Town of Hilton Head Island
Design Review Board Special Meeting
Friday, June 26, 2020 – 9:00 a.m.
AGENDA

Town of Hilton Head Island
Design Review Board Special Meeting
Wednesday, May 27, 2020 at 9:00 a.m.
MEETING MINUTES

CANOPY-1&2

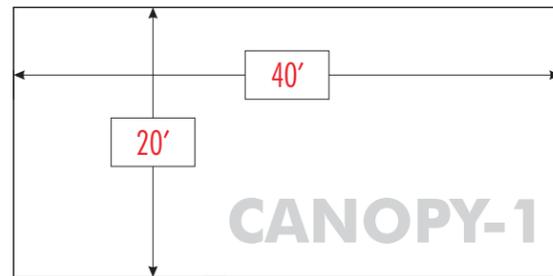
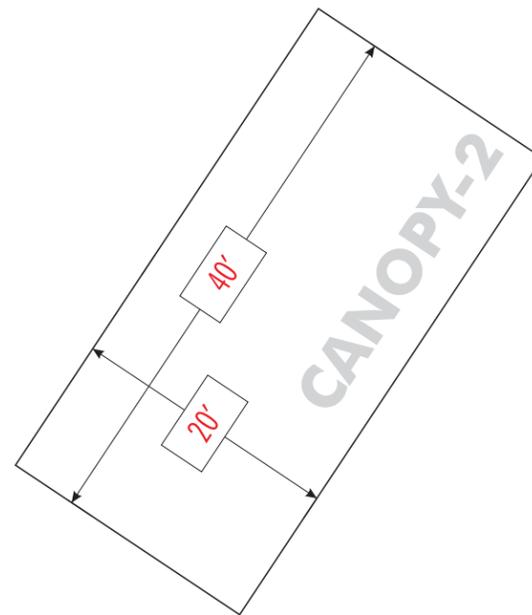
1. Modifications are limited to pump and sign rebranding. Building and canopy color changes are not approved. Freestanding sign color is also not approved.
2. Changeable copy maximum height is 8 inches.
3. Bollards and curbing are to match the stucco building color on building /columns.

| DESIGN GUIDE/LMO CRITERIA | Complies Yes | No | Not Applicable | Comments or Conditions |
|-------------------------------------------------------------|--------------------------|-------------------------------------|--------------------------|----------------------------------------------------------------------------------------------------------------------------------------------------------------------------------------------------------------------------------------------------------------------------------------------------------------------------------------|
| Structure is designed to be appropriate to the neighborhood | <input type="checkbox"/> | <input checked="" type="checkbox"/> | <input type="checkbox"/> | The proposed modification to the trim, canopy and sign structure colors is not in keeping with the character of the surrounding Coligny development or with other elements on the building such as the storefront. The existing green roof and detailing is consistent with the surrounding development and other details on the site. |

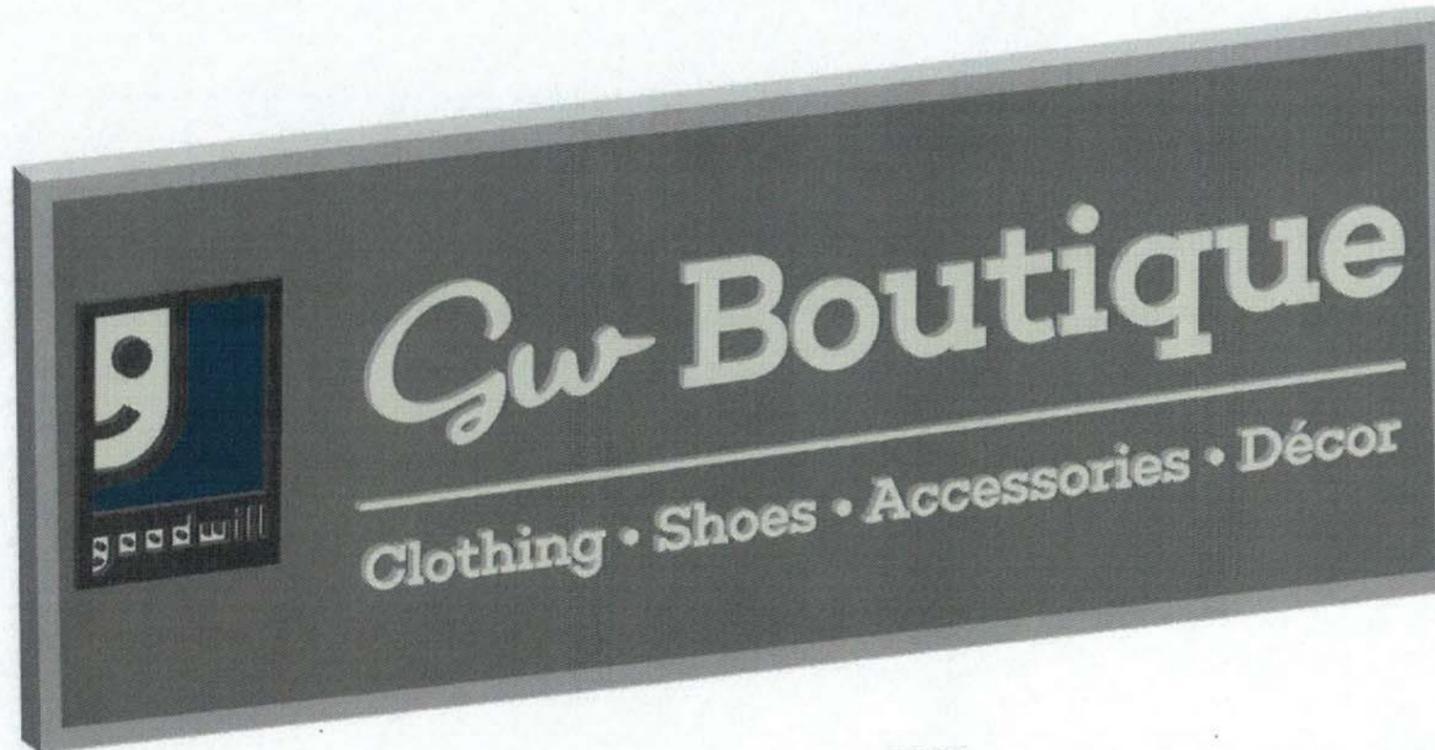
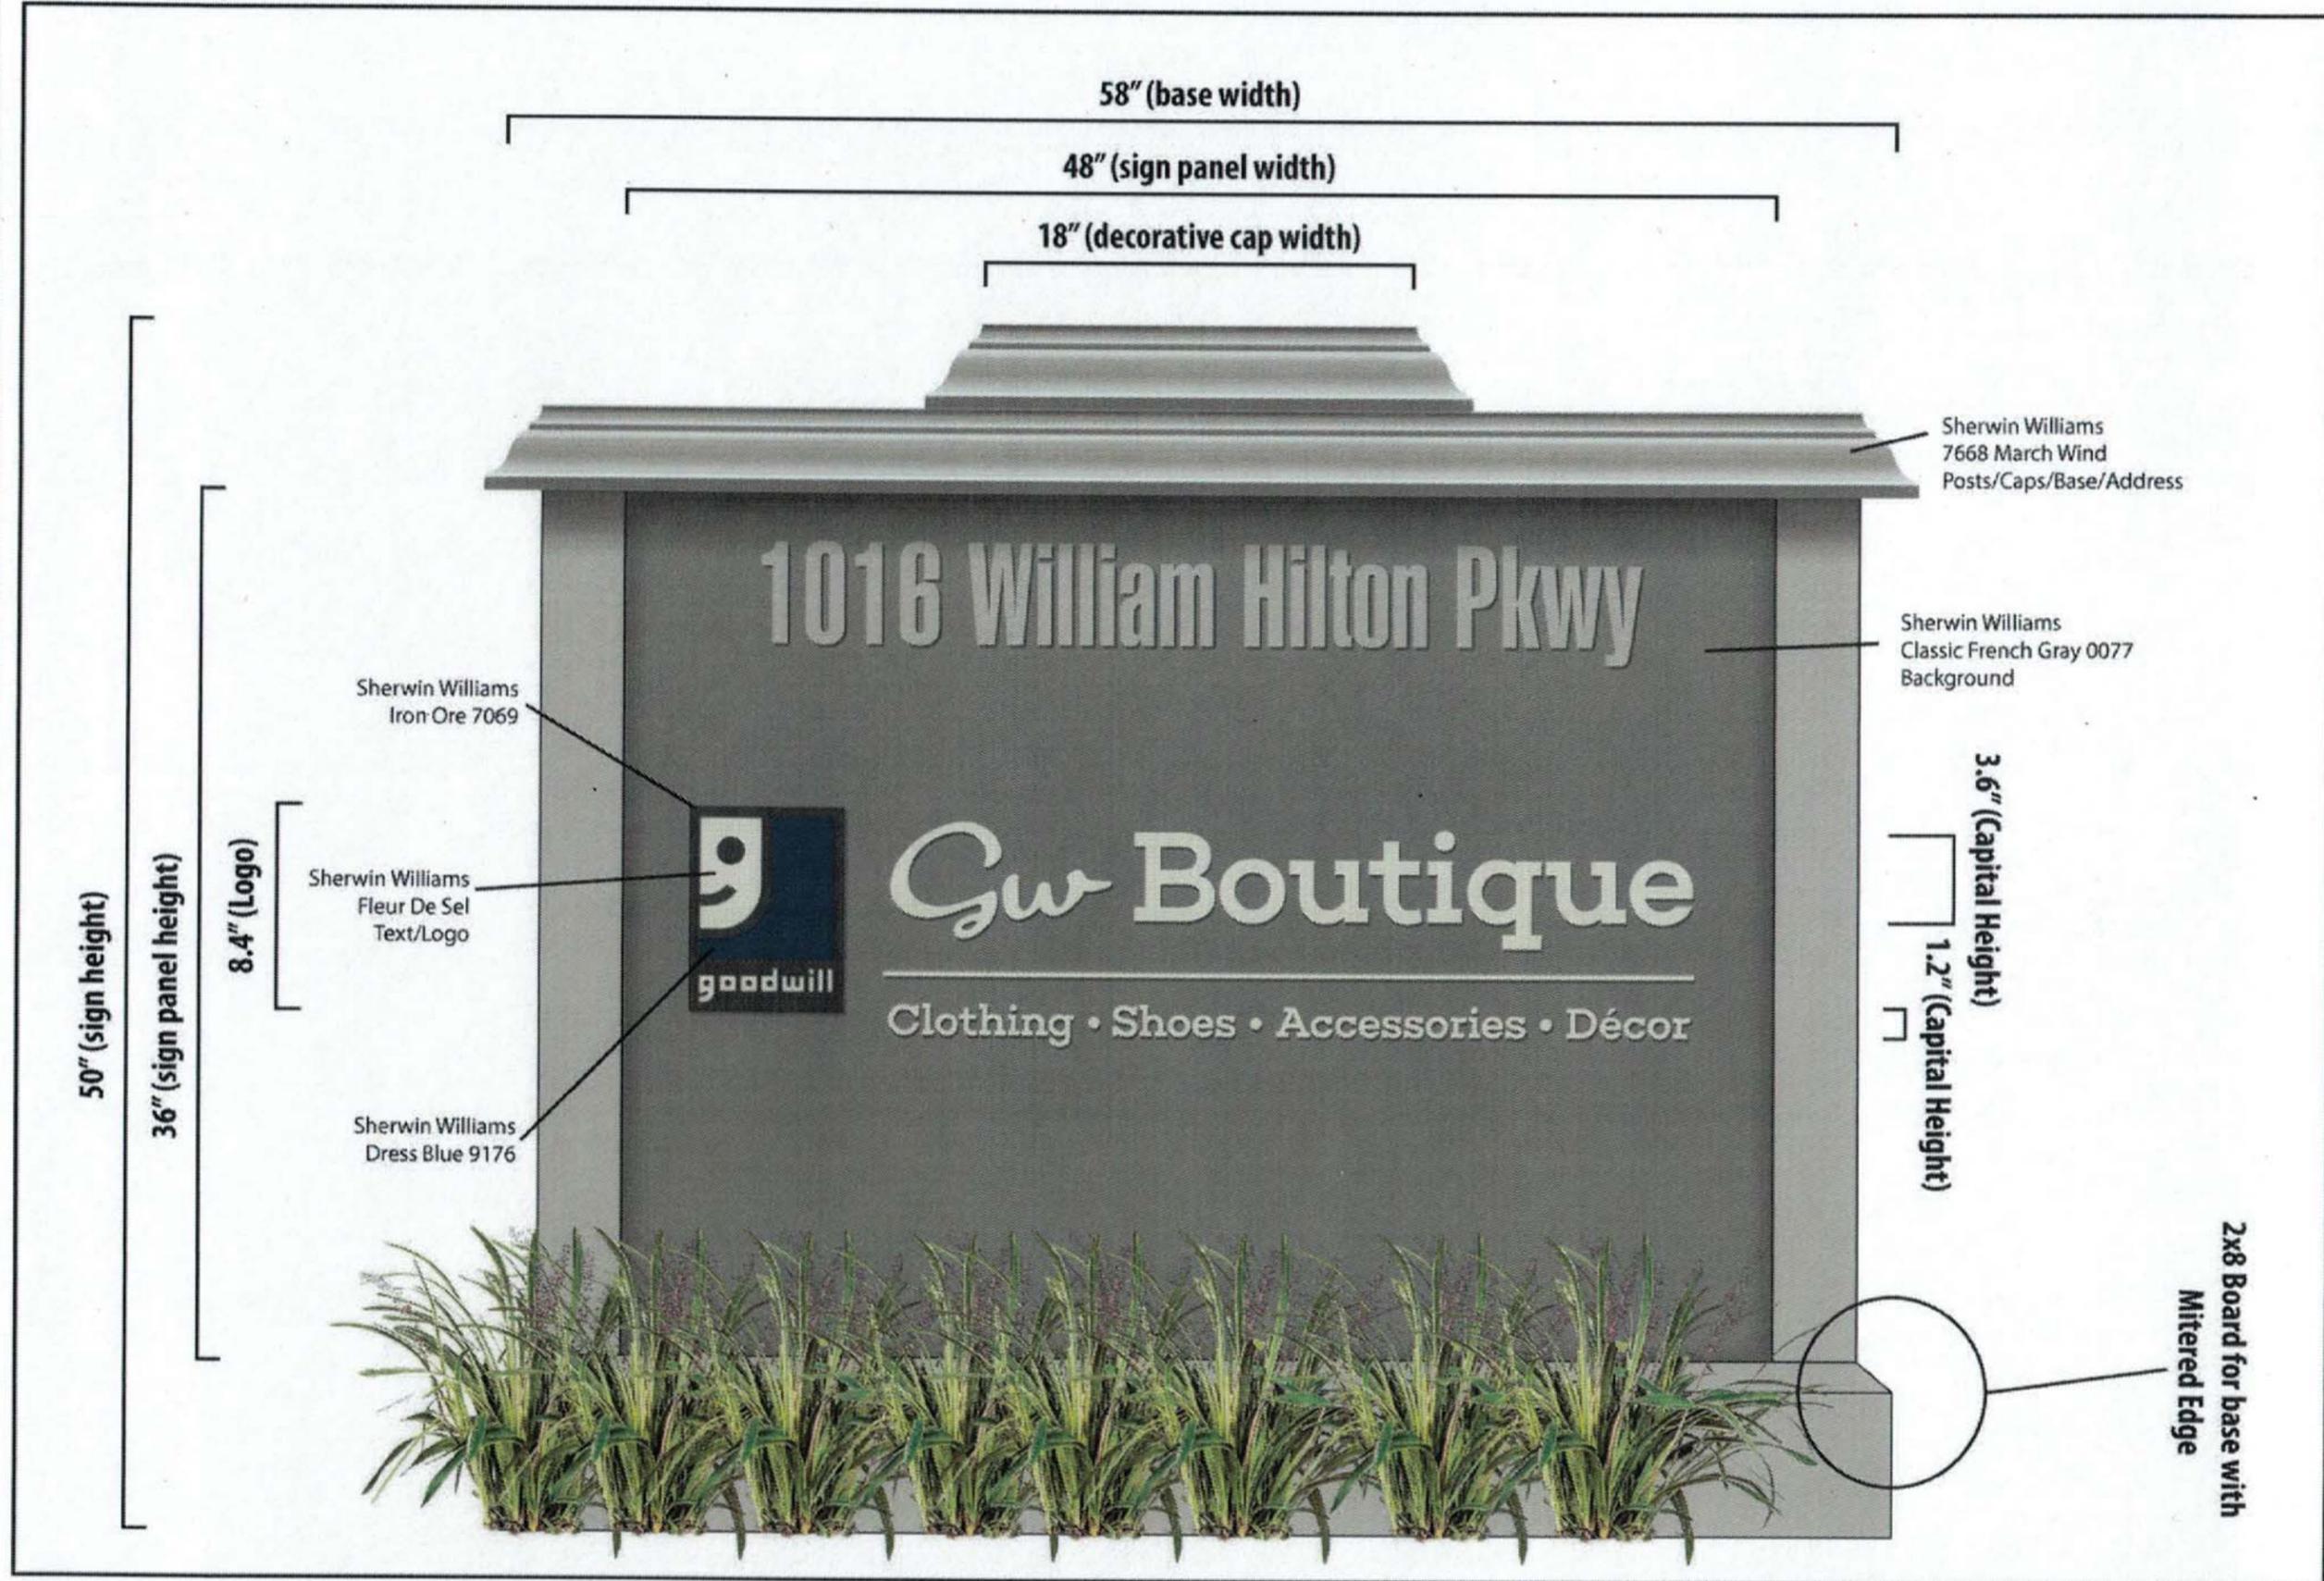
1. The background shall be a woodgrain texture rather than smooth finish.
2. Delete the border around the address.
3. Planter shall be planted with Ophiopogon japonicas, Mondo Grass, 1 gallon container, 12 inches on center or equivalent to be approved by staff.
4. Power wash unchanged parts of monument.
5. Entrance and exit signs shall be painted to match the monument sign.
